ADDENDUM TO THE CONTRACT DOCUMENTS

ADDENDUM NO. 002
	Project: Solano Community College District Building 1600 Modernization Project Project Number: 25-009
	Date: July 12, 2024

AD2 - A0.04

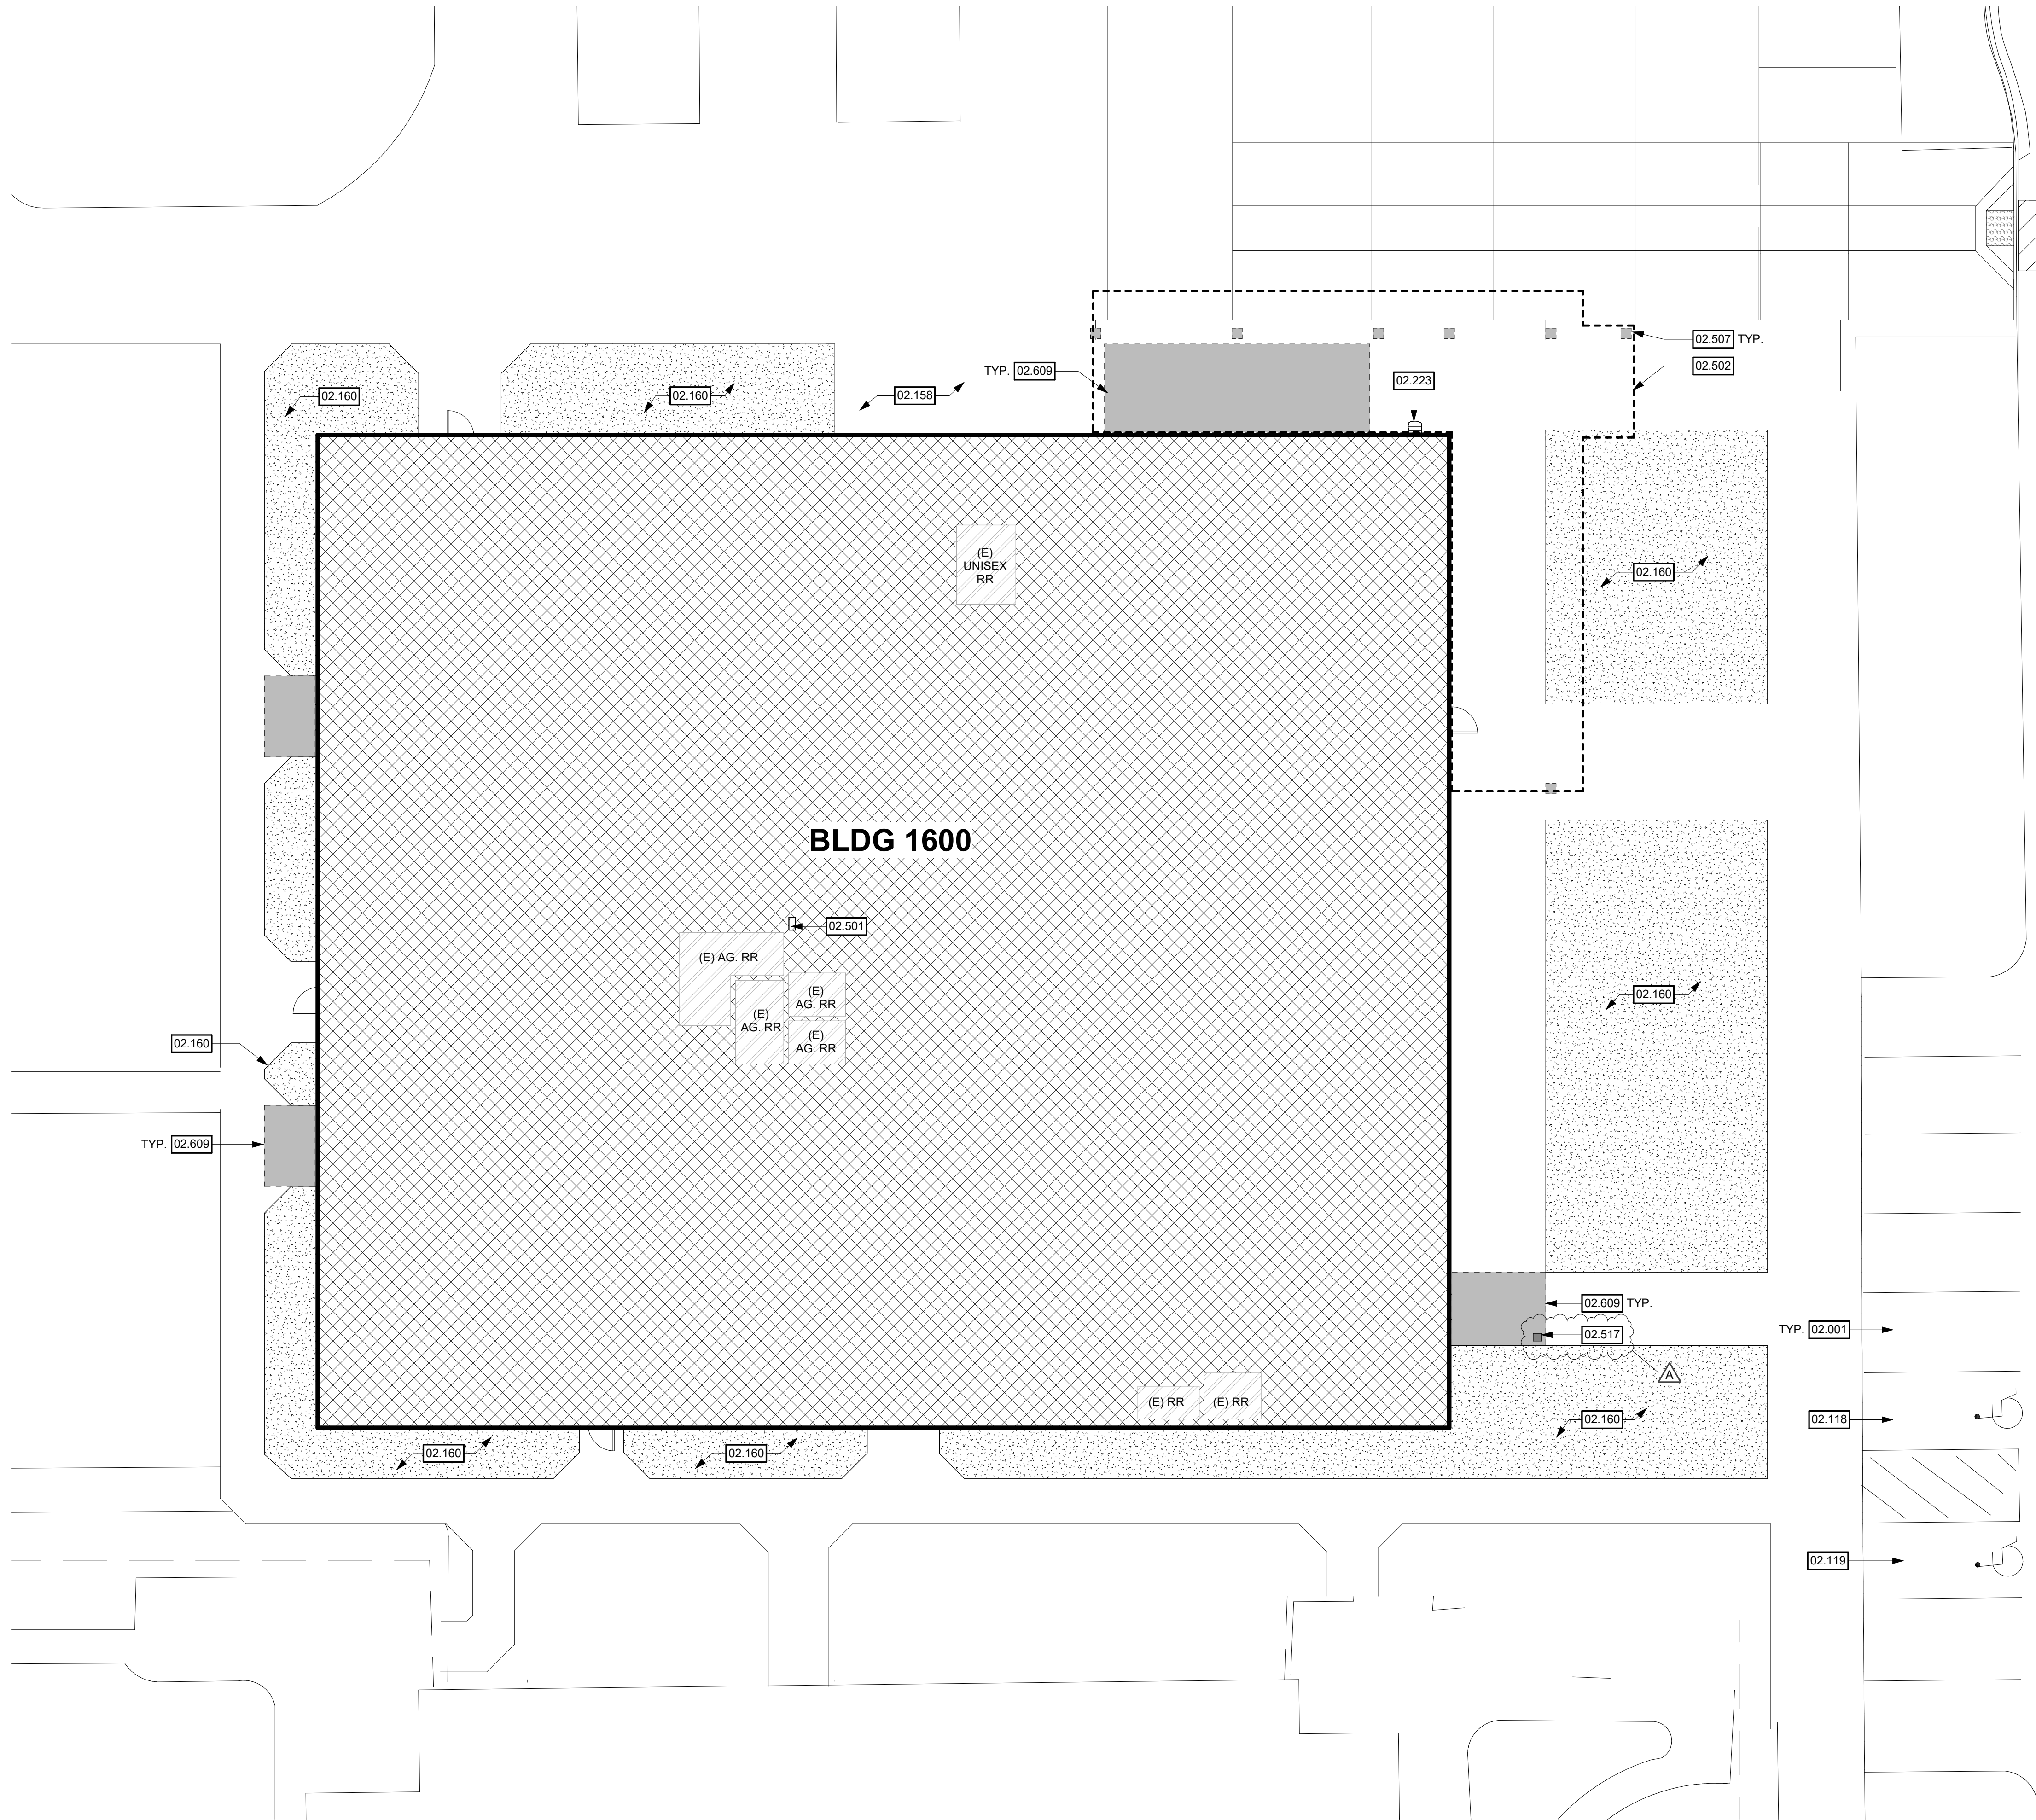
Revise: Exit analysis for room 1633 per attached sheet AD2-A0.04

Delete: Exit analysis for room 1634 per attached sheet AD2-A0.04

Revise: Building area analysis actual floor area per attached sheet AD2-A0.04

AD2 - A1.01

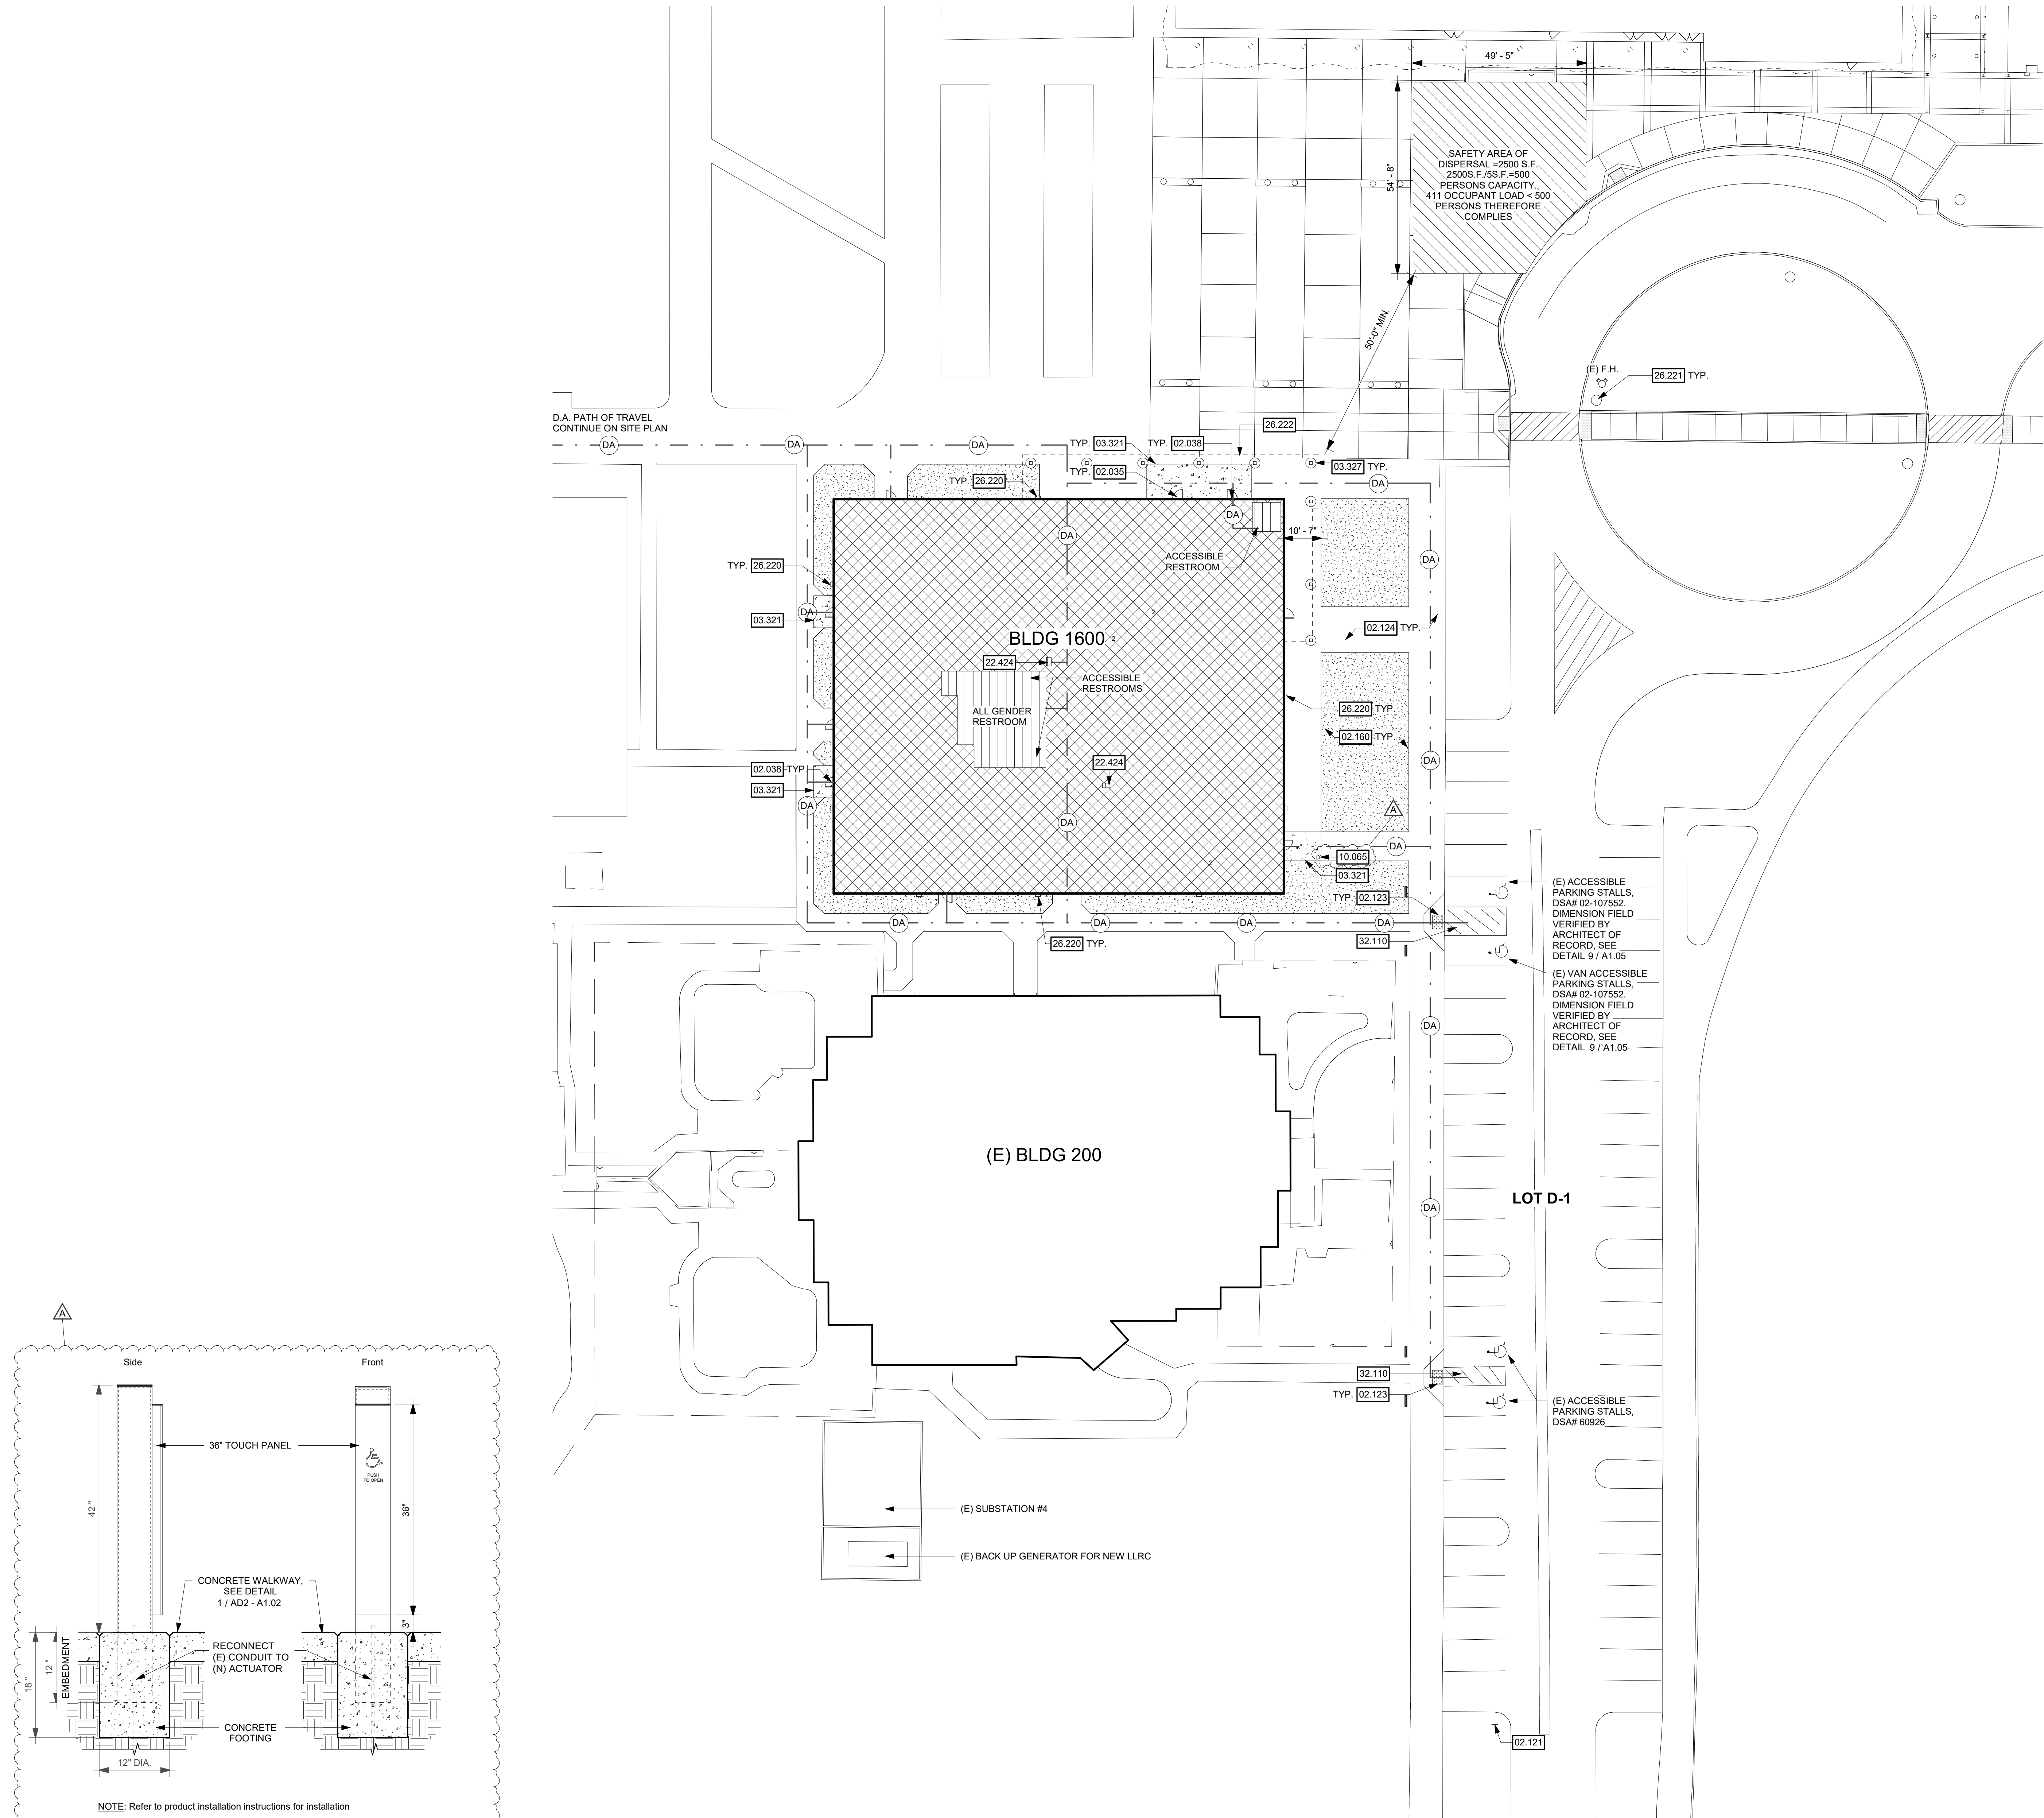
Revise: Keynote 02.515 to keynote 02.517 to read: “Disconnect power supply and demo (e) accessible door actuator. Actuator to be replaced, enlarged new site plan on AD2-A1.02” per attached sheet AD2-A1.02

1 DEMO FLOOR PLAN
SCALE: 3/16" = 1'-0"

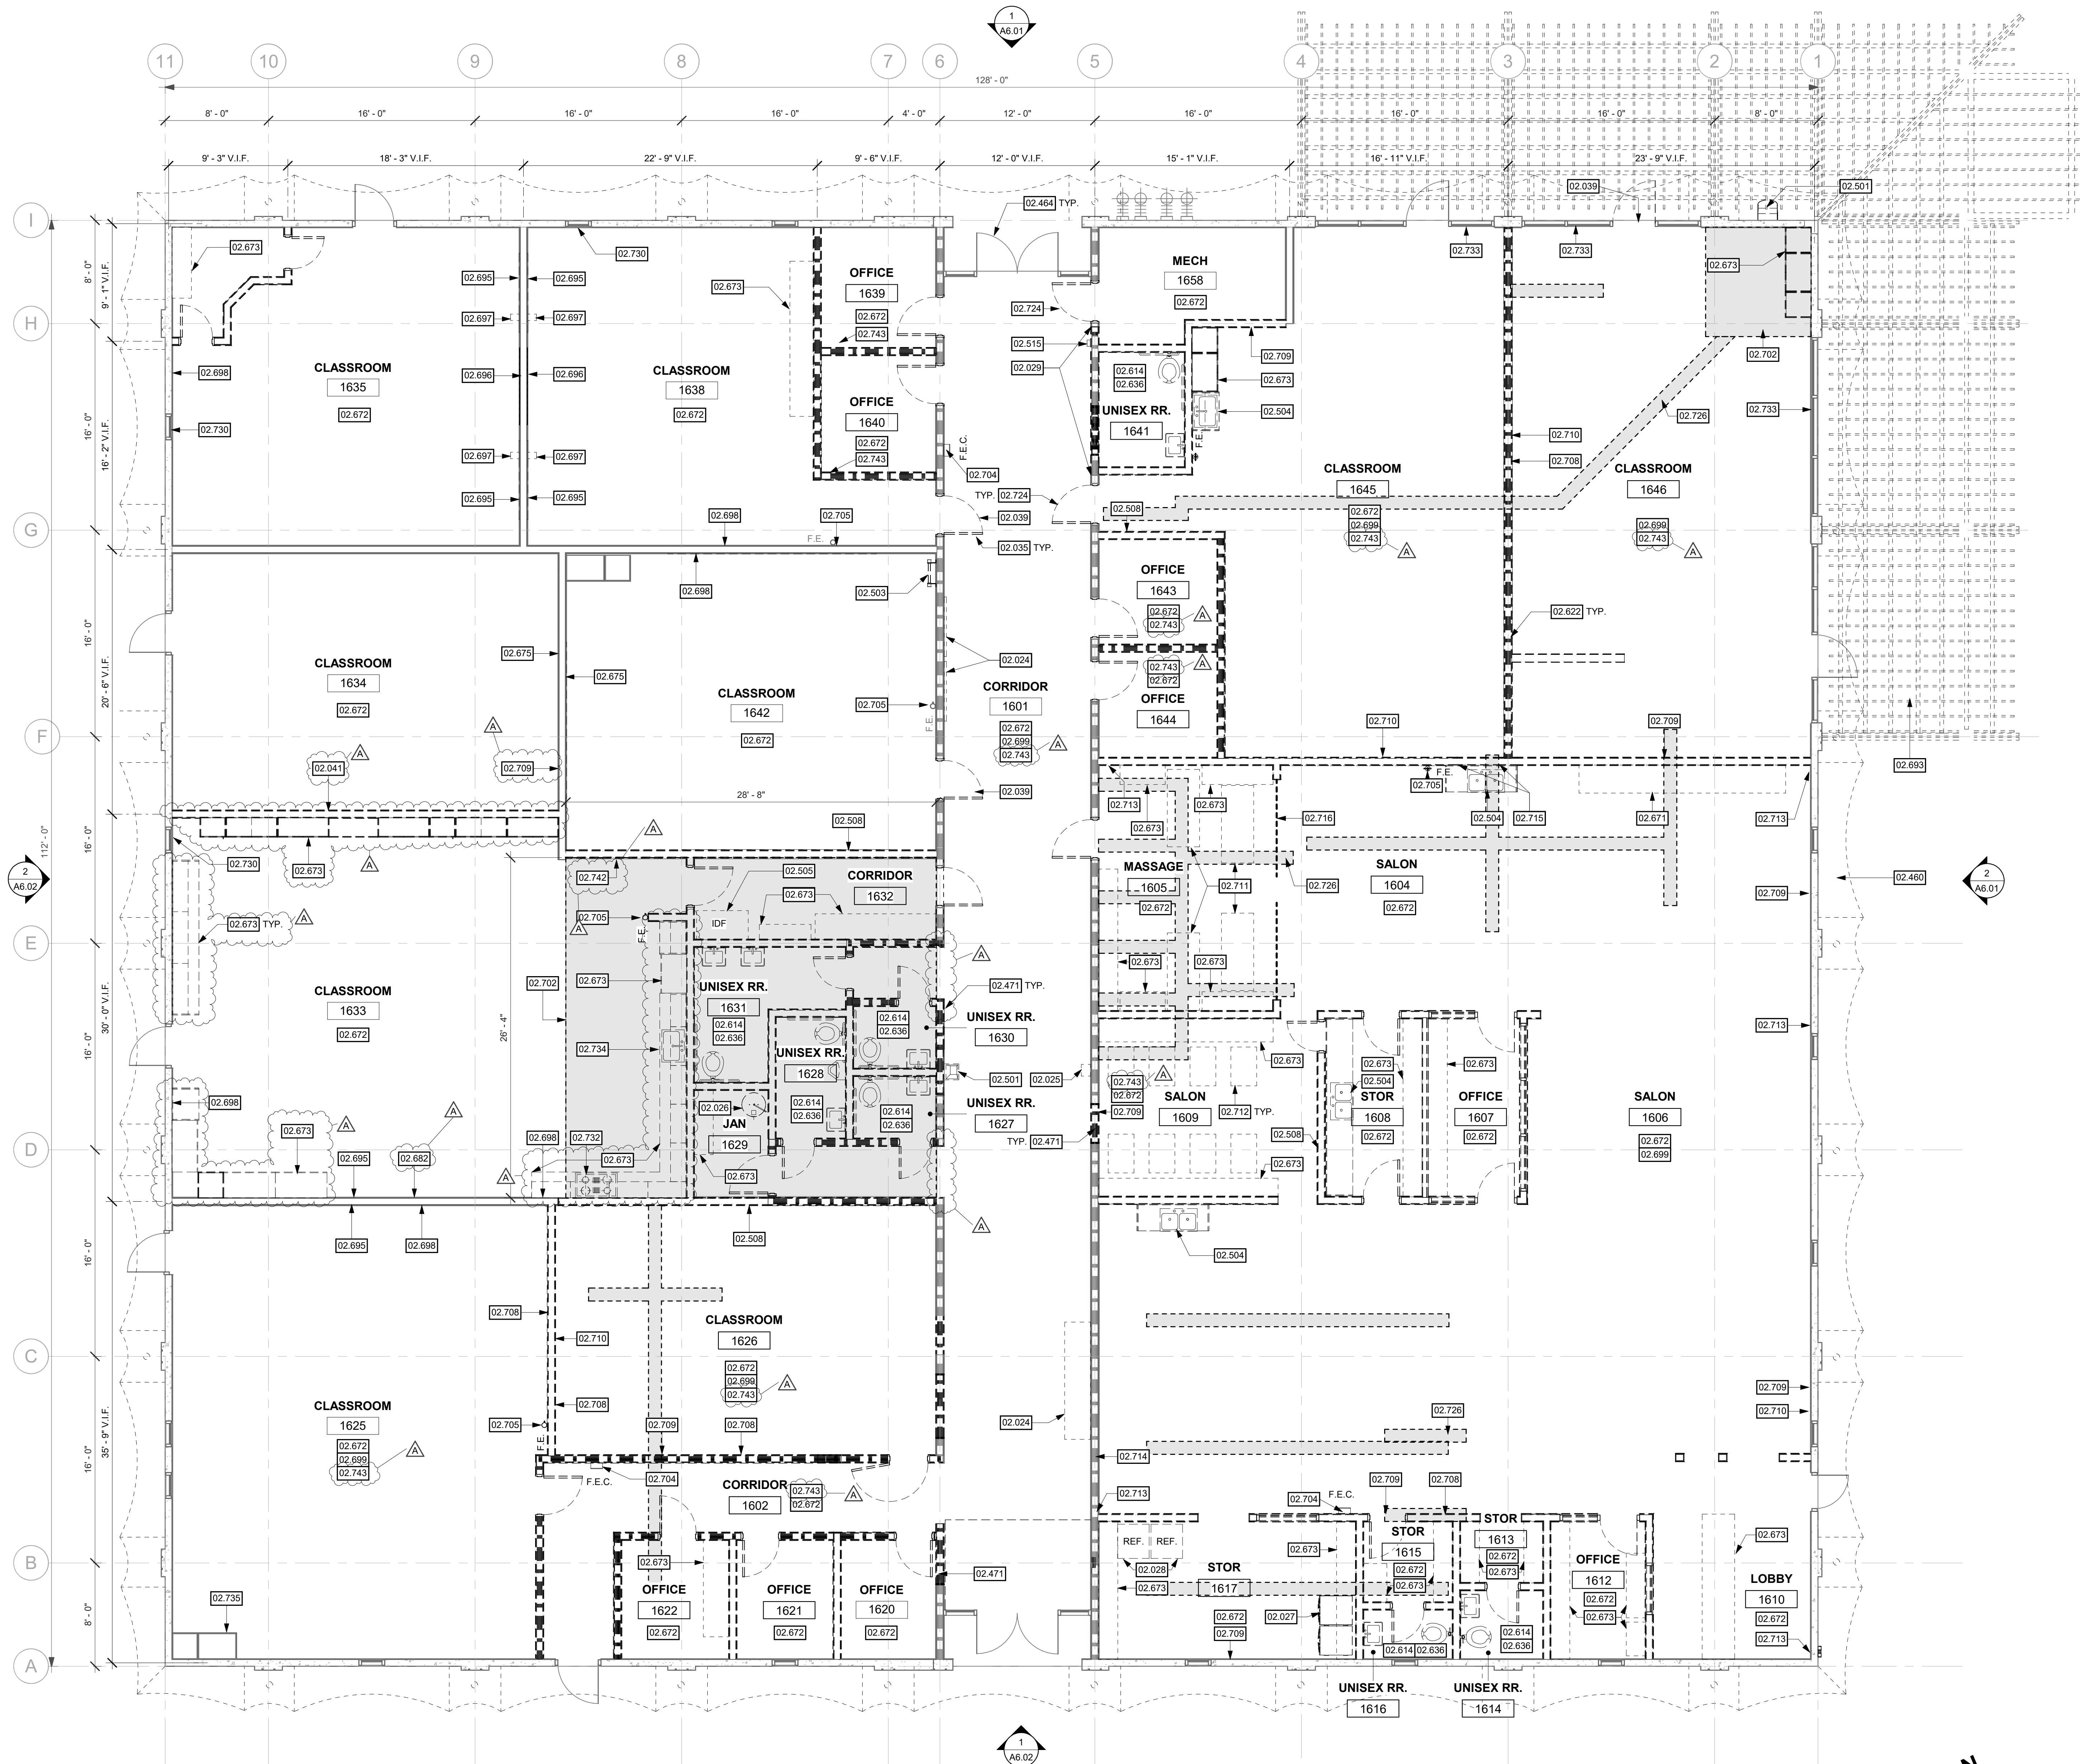
Revise: Keynote 02.675 to 02.682 in room 1633 to read: “Remove (e) projector screen and turn to district” as shown per attached sheet AD2-A2.01

Revise: Keynote 02.706 to 02.742 in room 1633 to read: “Remove and salvage (e) tack panel, reinstall per new plan” as shown per attached sheet AD2-A2.01

Revise: Casework and wall demo scope in room 1633 as shown per attached sheet AD2-A2.01

Revise: Keynote 02.698 to 02.709 in room 1634 as shown per attached sheet AD2-A2.01

Add: Keynote 02.743 to room 1602, 1609, 1625, 1626, 1643, 1644, 1645, and 1646 to read: "Demo all wall finish and gyp board in the room" as shown per attached sheet AD2-A2.01

Revise: Wall layout on grid 6 between grid E and D as shown per attached sheet AD2-A2.01
